## Proposed Burlington Quarry Expansion JART COMMENT SUMMARY TABLE – Visual Impact Assessment

**NELSON QUARRY VIA (JUNE 2021) - NEC REDLINE** Attachment for NEC JART Comments - September 2021

Photo 50: Approx. 2322-2402 2 Side Road. Facing Towards Proposed Southern Extension.

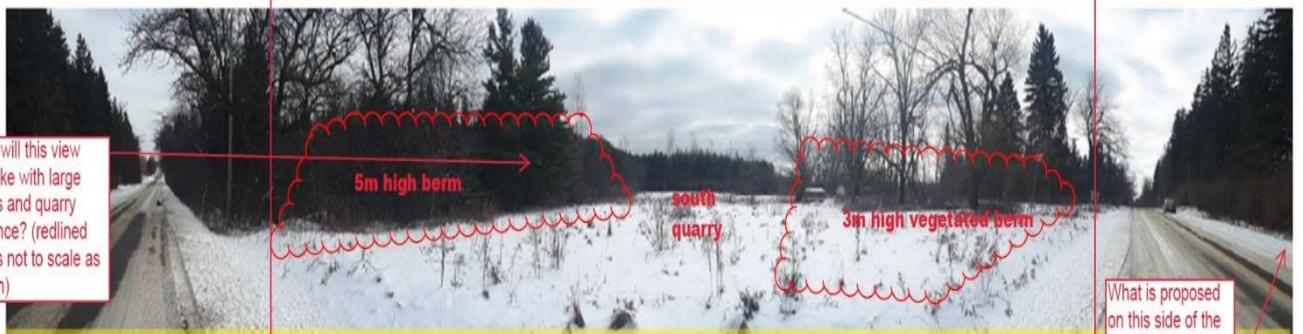
What will this view look like with loss of open view and proposed berming?

What will this view look like with large berms and quarry entrance? (redlined berms not to scale as shown)

What is proposed on this side of the road? Is there a crossing here? Vegetation/berm removal?

These are the views of concern requiring further study. Photo simulations are required. Due to distortion in the panoramas, new base photography may be required for these views to ensure accuracy in the photo simulations.
